Figure A-1. GA 35 Antenna Installation Drawing

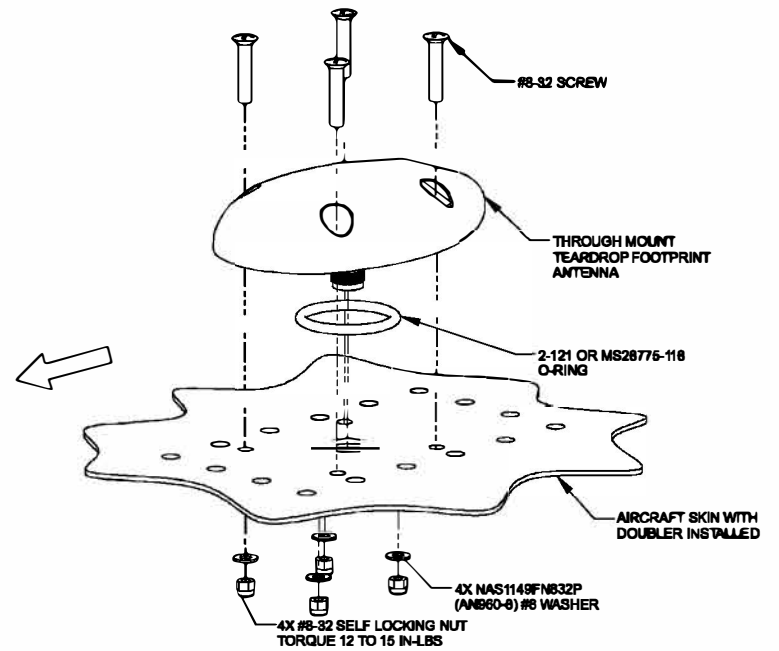
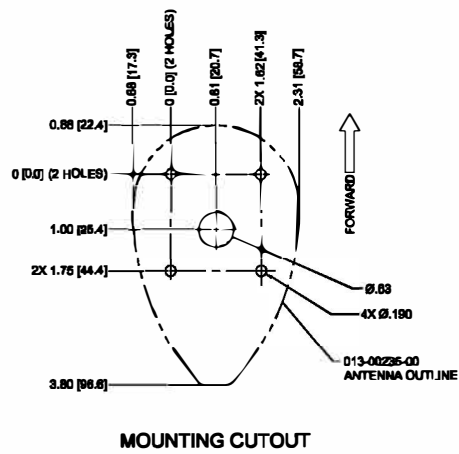
CAUTION

GA 35 antennas with serial numbers below 110000 required screws with 80° countersink angle and most aviation fasteners (AN509) are NOT compatible. Serial numbers 110000 and higher, AN509 hardware is compatible.
